# Venice Neighborhood Council

## Land Use & Planning Committee (LUPC) STAFF REPORT

**City Case No:** [DIR-2026-21-CDP-ADJ-MEL-SPPC](#)

**Address of Project:** 1219 Abbot Kinney Blvd

1. ADJ

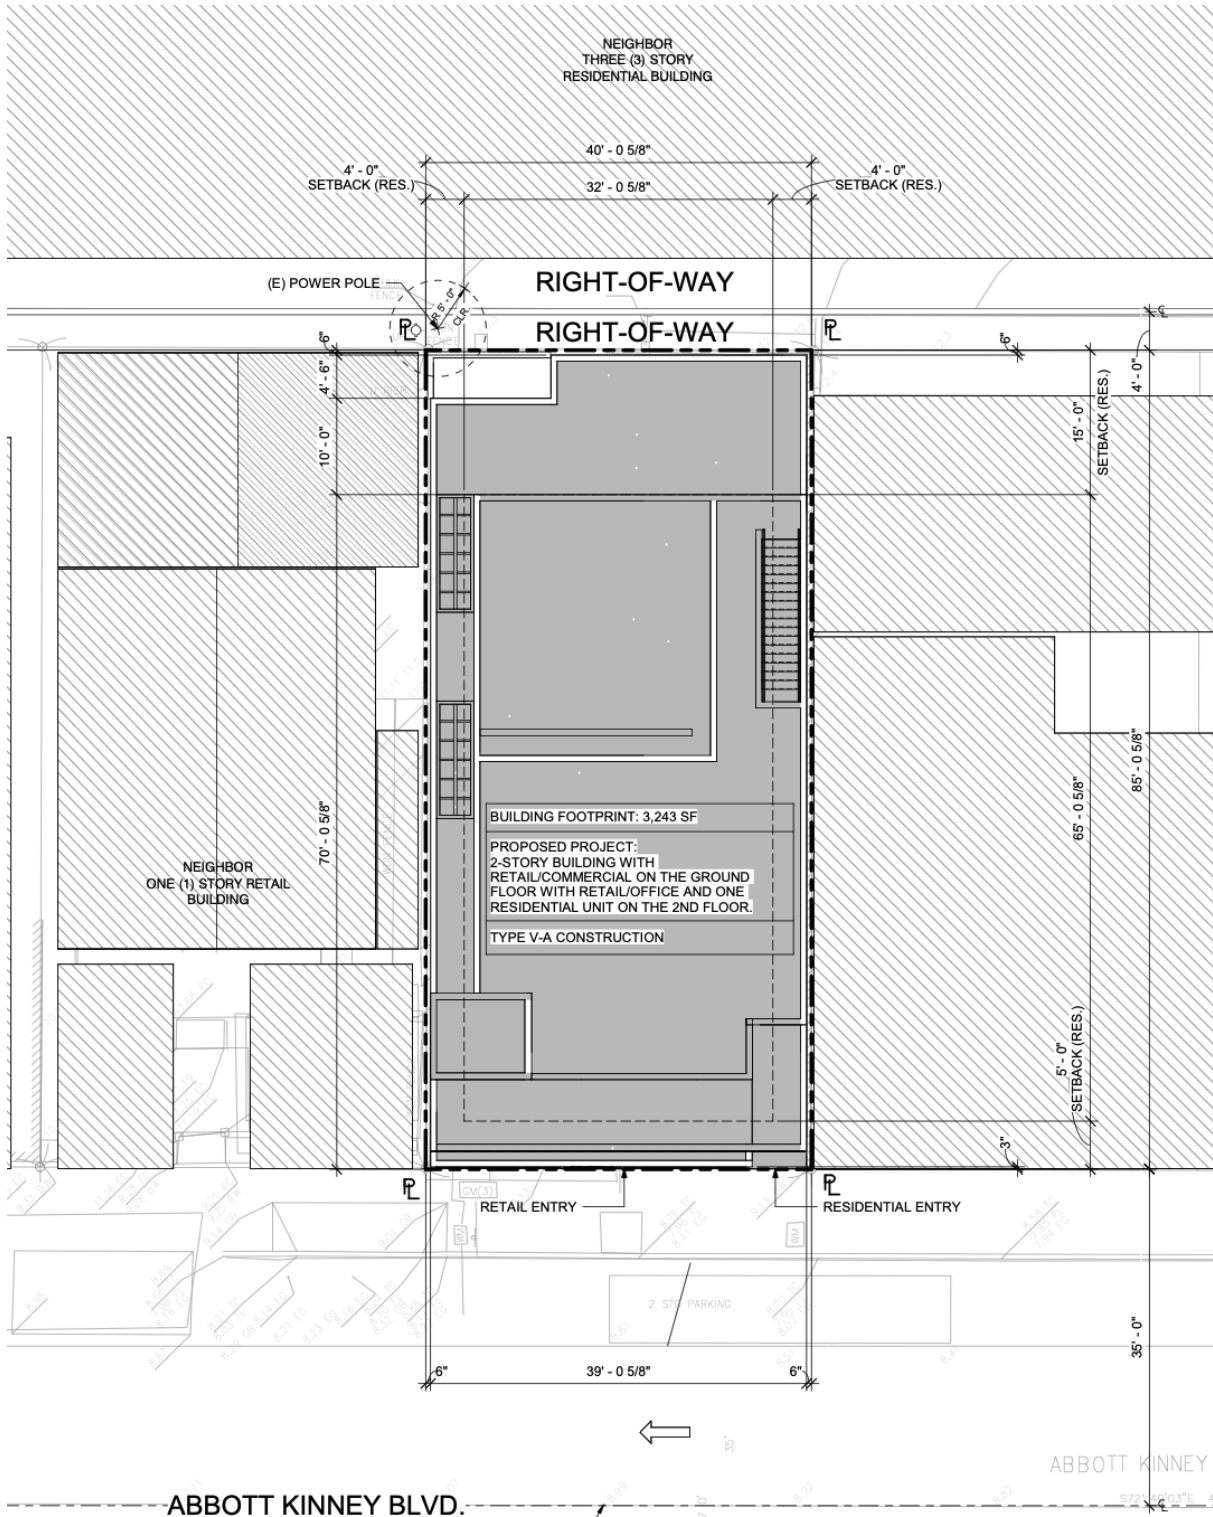
Relief is requested from LAMC 12.11.C.2 for a reduction to a 0' side yard setback along both property lines to allow for enclosed stairs on the east and an elevator on the west, both to provide access to the second floor live/work unit. However, this appears to be a convenient enhancement as it is not a necessity to have both an enclosed staircase and an elevator and not having one or the other would not be a hardship to the project.

The findings for approval of an ADJ (adjustment) are in LAMC section 12.28-A. Nothing in the applicant's proposed findings is evidence that site characteristics make strict adherence to the zoning regulations impractical or infeasible. Thus, it appears that the request might be a convenient enhancement, but it is not a necessity due to hardship or any site characteristic that makes compliance with the regulations impractical or infeasible. Prior unpermitted commercial use at this property or any other surrounding property is not a special circumstance supporting this request.

1ST FLOOR / GROUND LEVEL FLOOR PLAN SCALE: 1/4" = 1'-0" 1

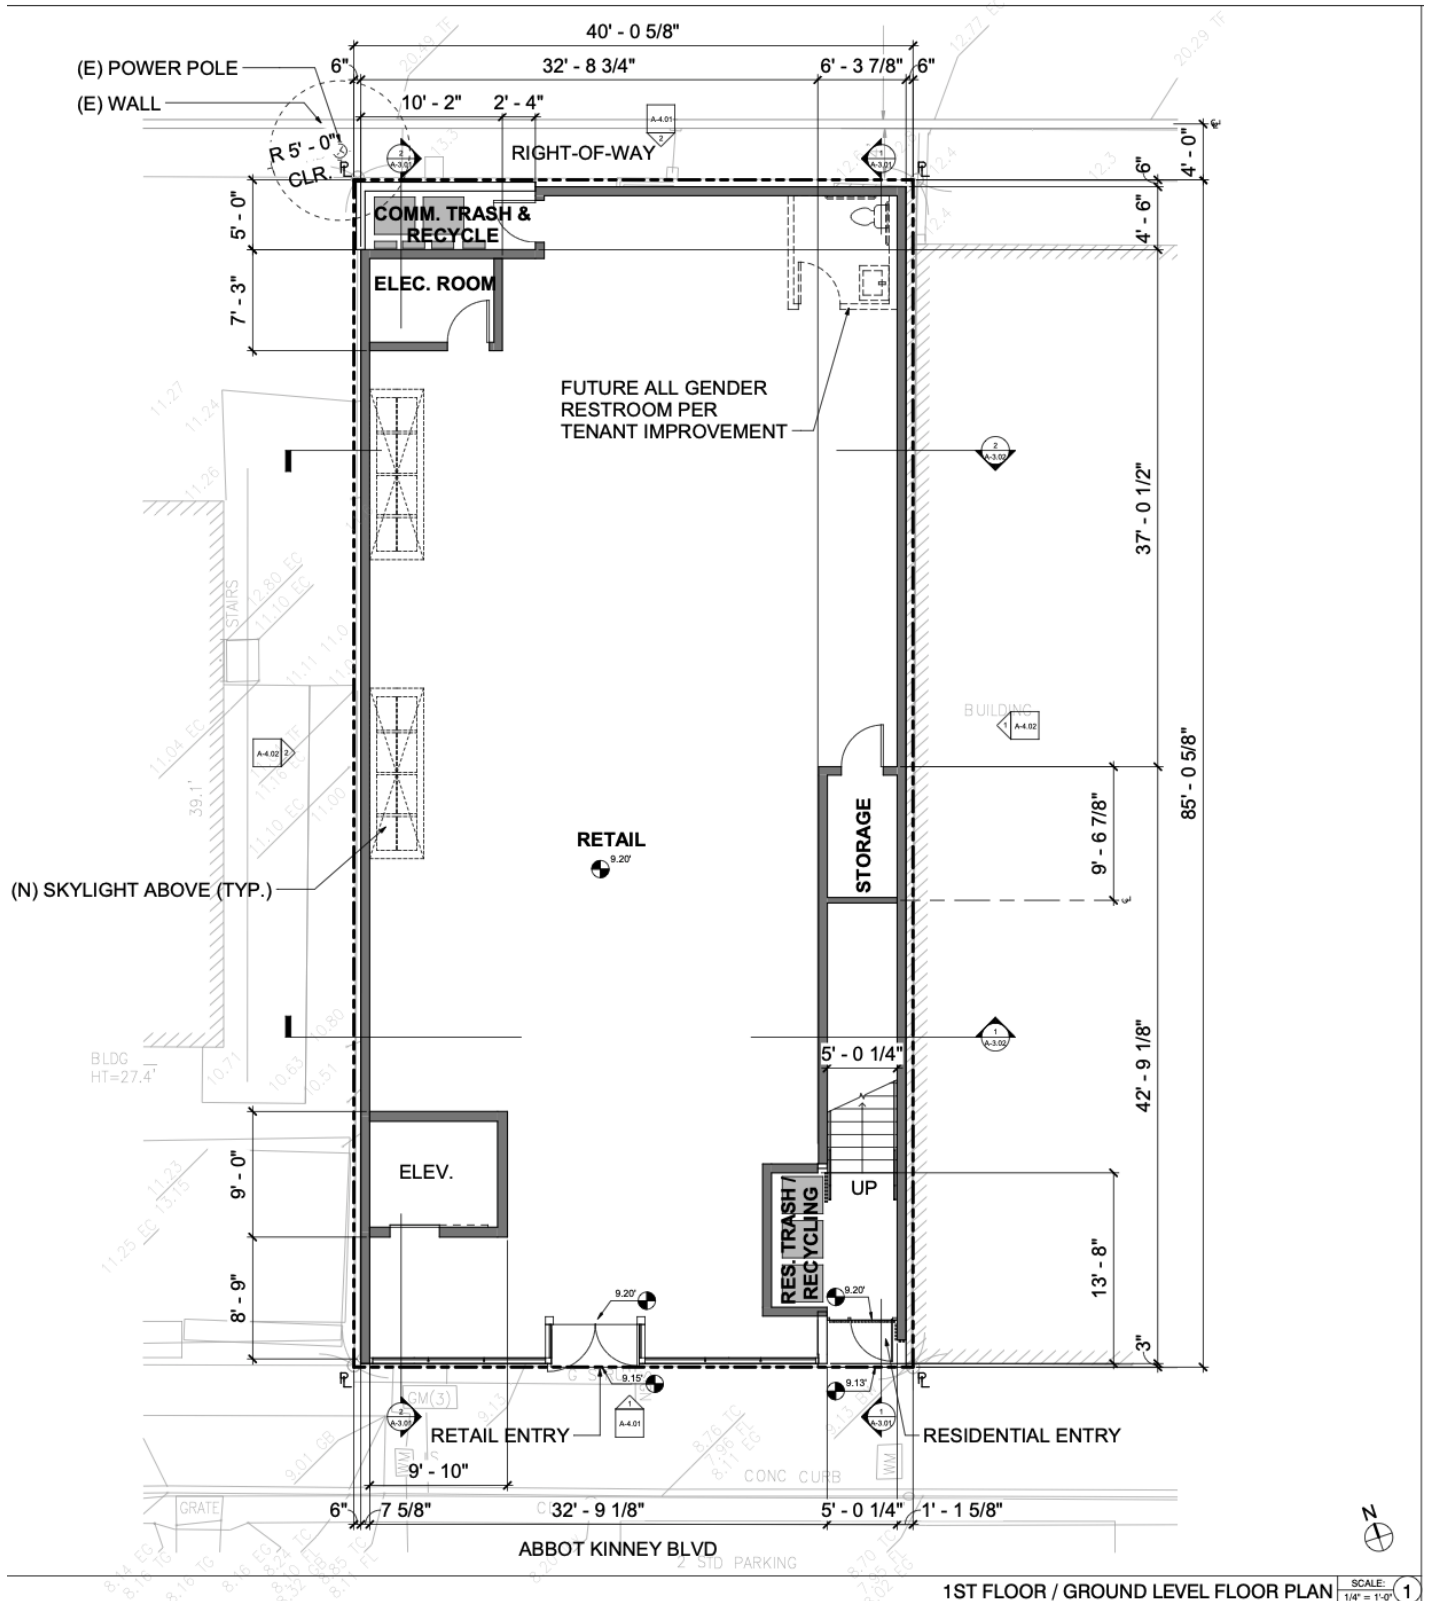
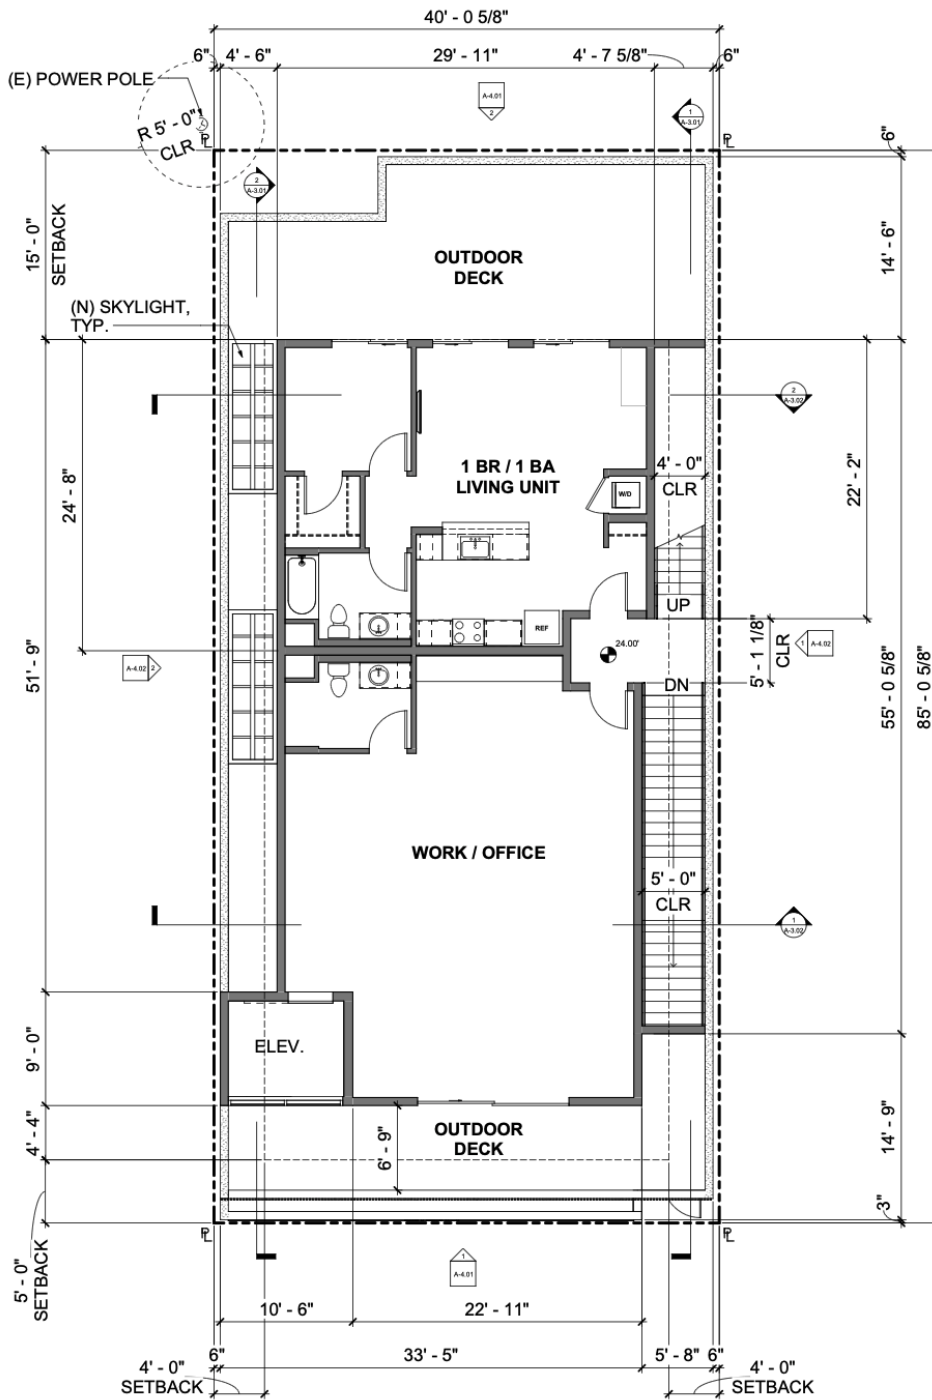
The project provides a small housing unit on the second floor that would be separately accessed via a side yard stairway from Abbot Kinney Blvd. The same stairway also accesses a live/work office area facing Abbot Kinney Blvd. This office area is also accessed via a large elevator from the retail floor. The way it is designed, it appears that the retail portion will expand to the upper floor and increase the retail capacity of the project.

The project asks for setback relief for the easterly part of the property to enclose the staircase to the second floor. This appears to be a convenient enhancement, as we are not aware of a requirement to have both an enclosed staircase and an elevator, and not having one or the other would not be a hardship to the project.

- 1) No setback relief on both side yards – 1 side only
- 2) 10 foot front setback for planting of large native trees (see also 5)
- 3) Alternative parking accommodations or a contribution to the in lieu fee parking fund
- 4) Addition of publicly accessible space on Abbot Kinney, a larger sidewalk
- 5) Green elements and permeable surfacing
- 6) Rainwater management
- 7) No rooftop use on top of second floor as residential buildings abutting to the north, and
- 8) An additional residential unit.

ROOF PLAN SCALE  
1/4" = 1'

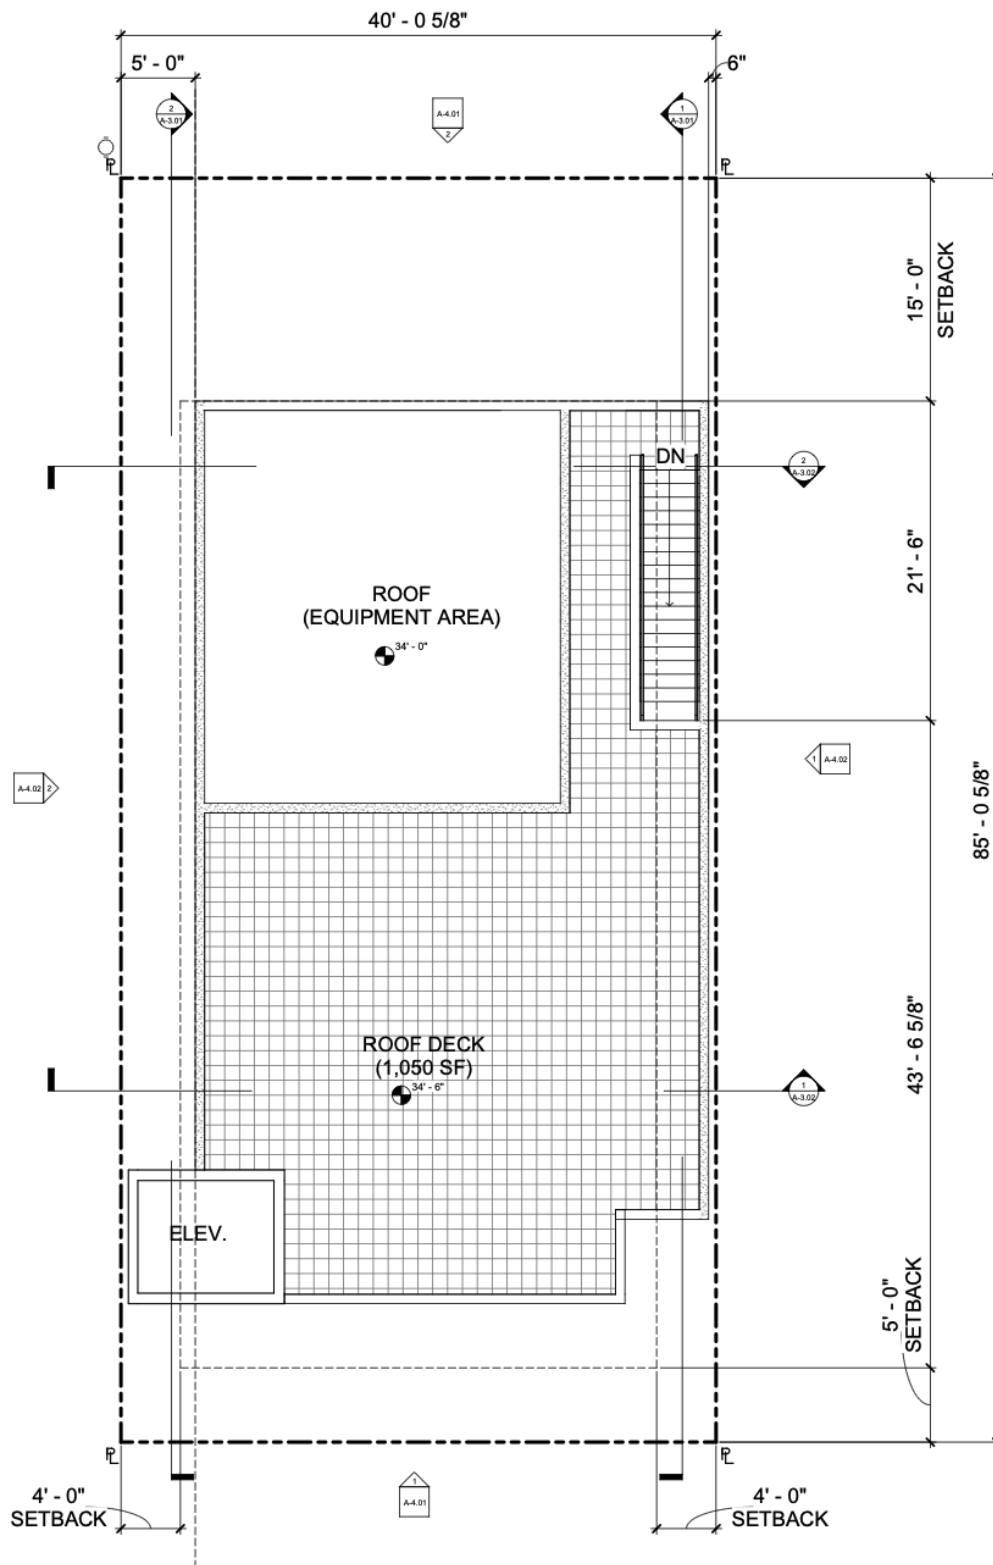
The project also has an extremely large roof deck, 1,050 sf, with no indication of who will have access to that roof top use.
